**Report Type:** DA Access Report  
**Reference Number:** 21083  
**Client:** GPG constructions  
**Site Address:** 76 Hobart Street, St Marys, NSW

# ACCESS REPORT

This Access Compliance Report is to accompany a Development Application for the development proposed at 76 Hobart Street, St Marys, NSW.

This development proposes a New Building (boarding house development) with a total of 17 Residential units. The development is within Penrith Council LGA. A total of 2 Accessible units and 2 Accessible parking spaces has been provided in the development.

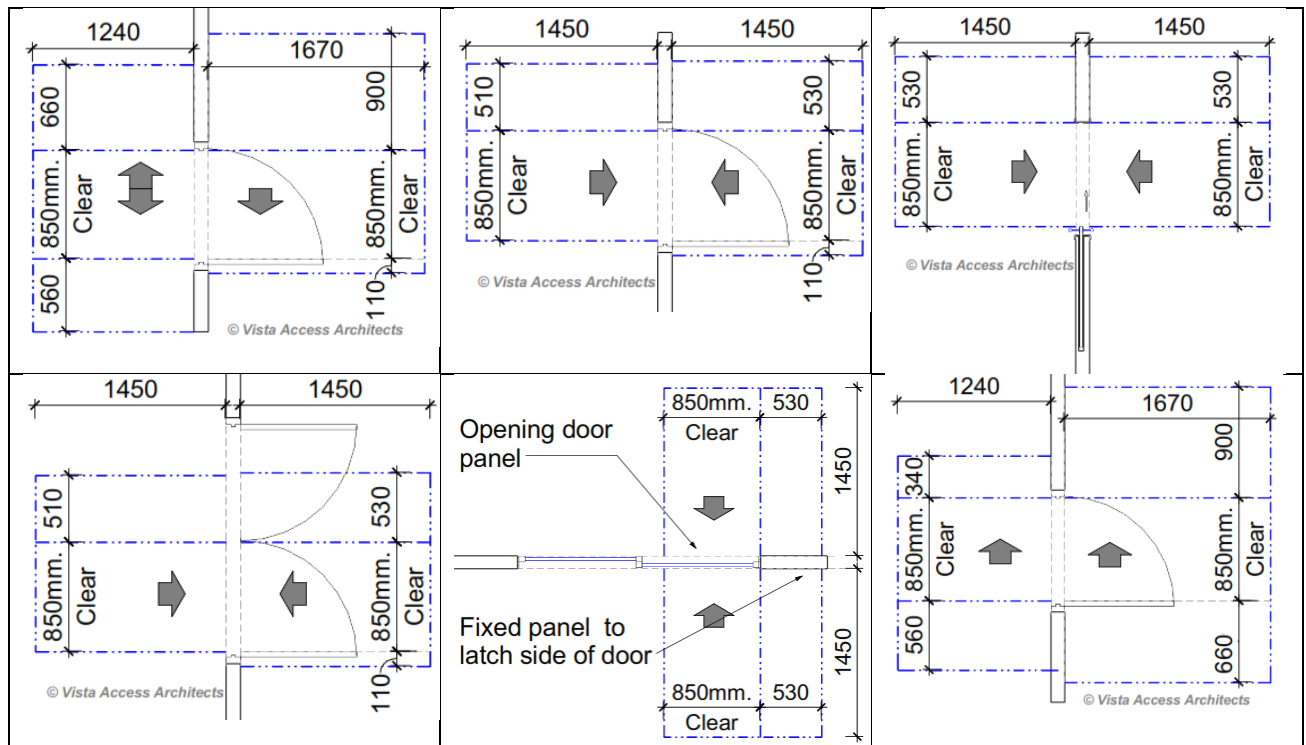
#### Compliance Comments

Complies

Access has been provided to Ground level containing Accessible carparking spaces.
